CALVERT CLIFFS
NUCLEAR POWER PLANT

SUBJECT: Calvert Cliffs Nuclear Power Plant
Unit No. 1; Docket No. 50-317
Response to Request for Additional Information: Relief Request for
Modifications to Pressurizer Heater Sleeve and Lower Level Nozzle Penetrations
(RR-PZR-01)

**RESPONSE TO REQUEST FOR ADDITIONAL INFORMATION:
ALTERNATIVE MODIFICATIONS TO UNIT 1 PRESSURIZER HEATER
SLEEVE AND LOWER LEVEL NOZZLE PENETRATIONS (RR-PZR-01)**

Sketch No. 1, Final Heater Sleeve Configuration

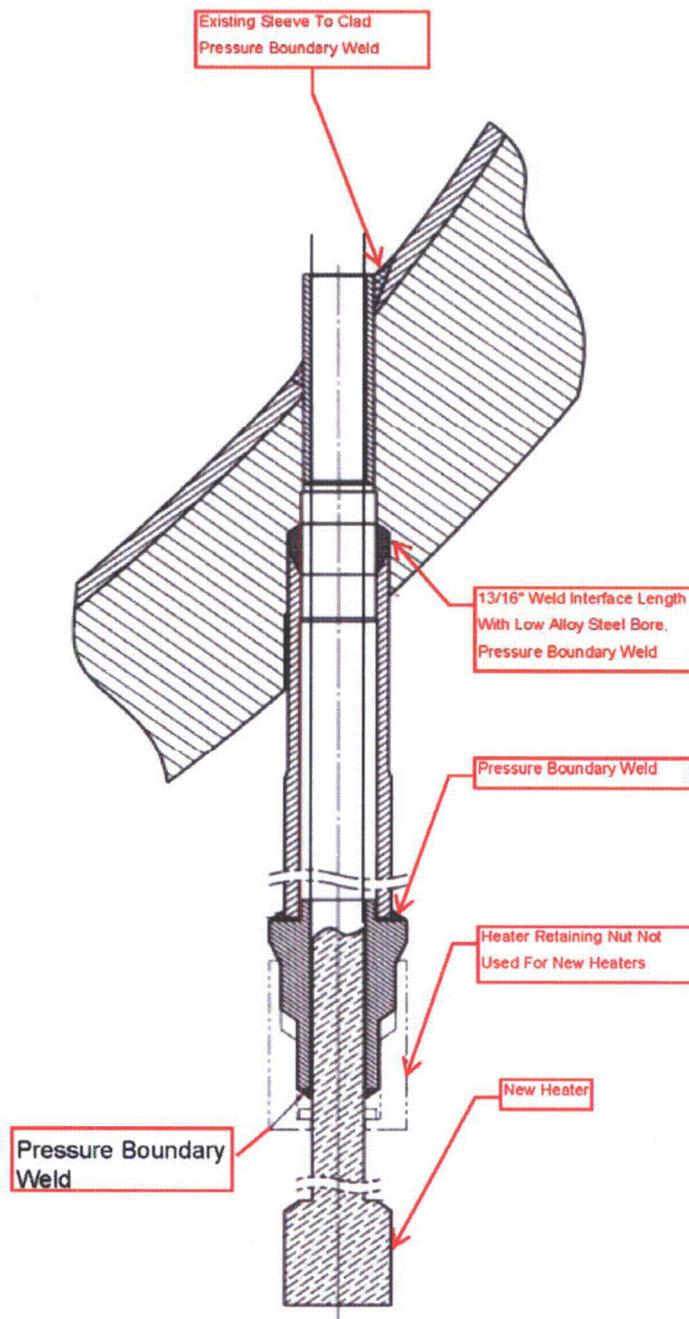
Section 4. The final sleeve configuration after modification is not clearly depicted in Figure 2. It is not clear in Figure 2 whether there is a gap between the bottom of the old sleeve and the top of the new sleeve inside the bore even though Figure 3 seems to suggest that there is a gap. Also, it appears that there is no weldment at the junction of the bottom of the new sleeve and the outside surface of the pressurizer head shell. Submit a new figure or modify Figure 2 to document the final configuration after modification. The figure for the final sleeve configuration should include the following information: (1) the heating element joining the new sleeve, (2) the axial length of the gap between the old and new sleeve, (3) whether a weld exists at the junction of the outside surface of the pressurizer and the new sleeve, (4) the original J-groove weld with respect to the original sleeve, (5) the system pressure boundary weld, and (6) relevant dimensions (e.g., weld length).

See Sketch No. 1 below.

- (1) The configuration is shown in Sketch No. 1 below.
- (2) The inside diameter of the new weld and bottom sleeve is greater than the outside diameter of the remaining portion of the original sleeve. The axial distance between the bottom end of the original heater sleeve and the top of the weld is approximately 1". The heater sleeve penetration counter bore diameter is approximately 1.75" and extends up to the high hillside intersection of the bore and outer surface of the bottom head. The final bore diameter is approximately 1.67" and extends upward into the bottom head approximately 3" at the penetration at the periphery of the heater sleeve penetration pattern. The sketch in the relief request is not to scale.

- (3) There is no weld between the sleeve/lower instrument nozzle and the outer surface of the pressurizer bottom head.
- (4) See Sketch No. 1 below.
- (5) See Sketch No. 1 below.

- (6) See Sketch No. 1 below.

Sketch No. 2, Existing Configuration

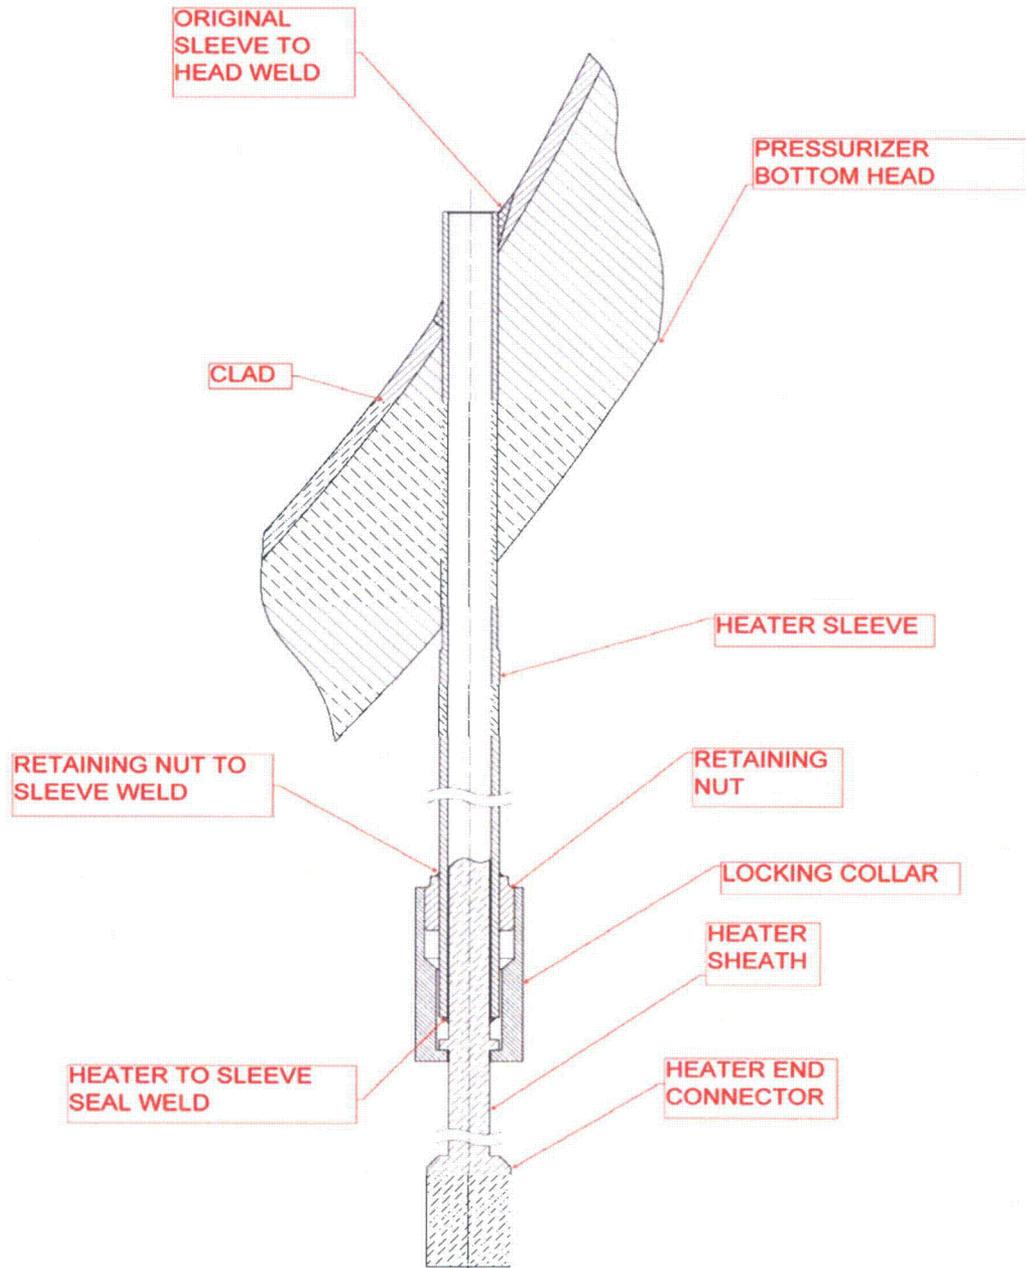
Section 4. Figure 1 shows various bore diameters after machining without explanation: (1) Explain why there are two different machined diameters in the bore and show their diametrical and axial dimensions; and (2) Include the location of the original J-groove weld in Figure 1.

Provide a diagram/figure that shows the existing configuration of the sleeve, heating element, and weld(s) with respect to the pressurizer lower head before modification.

- (2) The original J-groove sleeve to pressurizer bottom head weld is located on the inner surface of the bottom head. See Sketch No. 1 above and Sketch No. 2 below. The axial distance between the bottom end of the original heater sleeve and the top of the weld is approximately 1". The heater sleeve penetration counter bore diameter is approximately 1.75" and extends up to the high hillside intersection of the bore and the outer surface of the bottom head. The final bore diameter is approximately 1.67" and extends upward into the bottom head approximately 3" at the penetration at the periphery of the heater sleeve penetration pattern.

See Sketch No. 2 below.

Sketch No. 3, Examination Volume

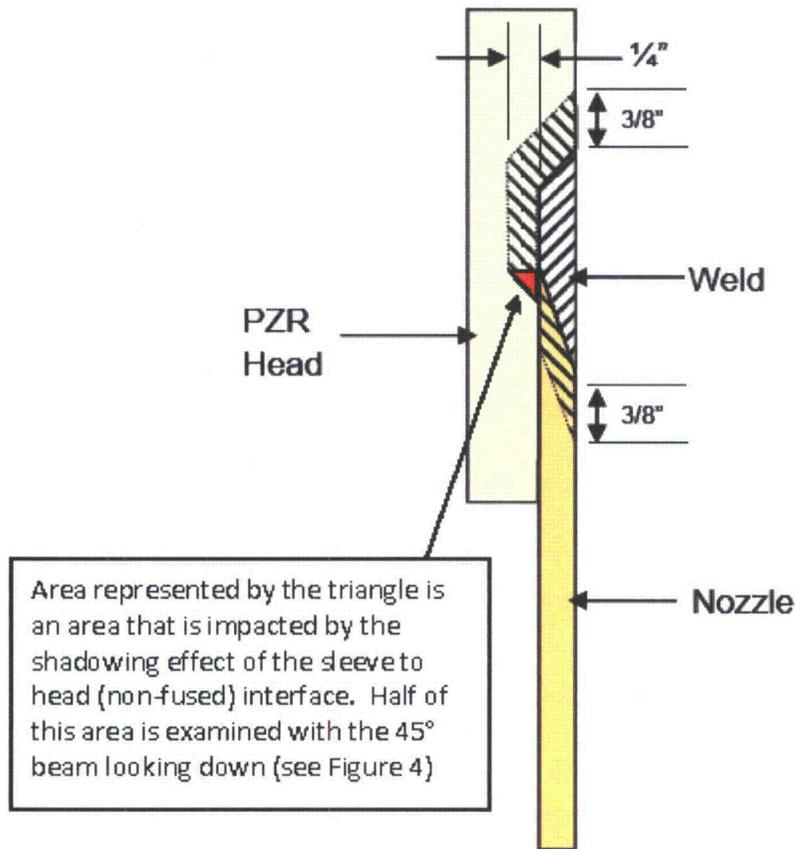
Section 5.2, page 6, mid-page, states that "...The UT is qualified to detect flaws in the new weld and base metal interface beneath the new weld... The volume of interest for UT includes the new weld, the bottom head low alloy steel base material heat affected zone, and the sleeve/nozzle to weld interface and will be covered to the maximum extent practical..." (1) Discuss to which ASME [American Society of Mechanical Engineers] Code Section and subarticles is the UT qualified, and (2) Section 5.3, page 7, 6th paragraph states that the weld configuration precludes examination of a small portion of the ferritic steel

heat affected zone that is shadowed by the interface of the OD of the nozzle. Provide the specific examination coverage (percentage of the required examination volume) of the small portion of the ferritic steel heat affected zone that cannot be examined. Provide the examination coverage of the heat affected zone that can be examined.

- (2) Although the heat affected zone is estimated to be approximately 3/32" deep, the examination procedure conservatively establishes the examination volume to include the weld and adjacent base metal areas identified in Sketch No. 3 below. Sketch No. 5 below also identifies the area affected by the shadowing effect of the non-fused sleeve interface. This area is partially covered by the 45° beam looking downward. The resulting area that cannot be examined by any of the examination angles is estimated to be less than 5% of the total examination volume. The examination coverage provided by each of the UT transducers is provided in Sketch Nos. 4 through 8 below and, as shown, adequately cover the specified examination zone.
